DIFFICULTIES DURING DRAINAGE OF WATER

with the electromechanical - ITRONIC - electronic dishwashers 60 cm (New design)

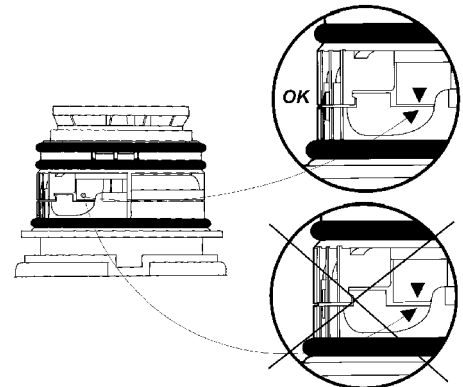
1. MOTOR

- a) Has the motor been properly installed into the bottom (adaption of motor-water collector).

- b) Is the vent hole of the water drainage worm clogged (O-ring improperly inserted, vaseline grease residue, contaminations).

- c) Intermediate washer of drainage pump wheel (must be lower than 0.5 mm).

Note: Items a) and b) have to be observed, even if the motor has been replaced.

4. ADDITIONAL VENT HOLE ON THE WATER COLLECTOR (WATER DRAINAGE SYSTEM)

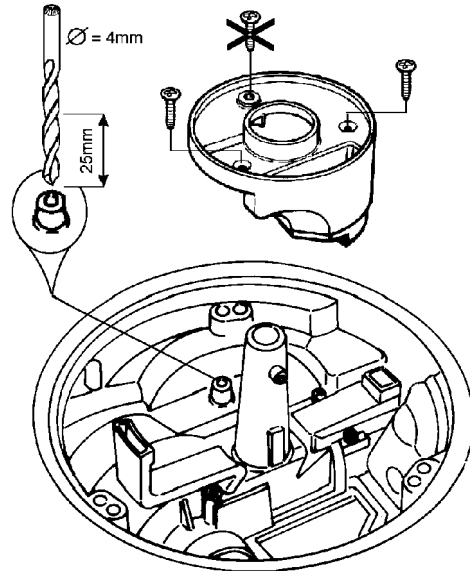
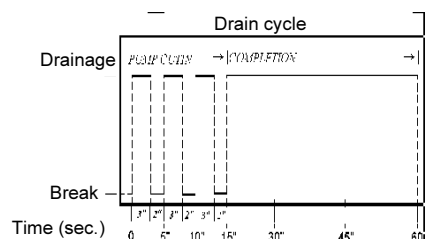
- a) Drill a hole in the vicinity of the water drainage system so that air bubbles, which might form in the water collector, can go out. In this way, the filling of the pump wheel is ensured.

- Remove the filter group.
- Loosen the screws at the middle filter assembly.
- Drill a hole (see fig.).
(dia. of drill 4 mm; depth max. 25 mm)
- Reassemble the filter assembly by using only two lateral screws.
- Reassemble the filter group.
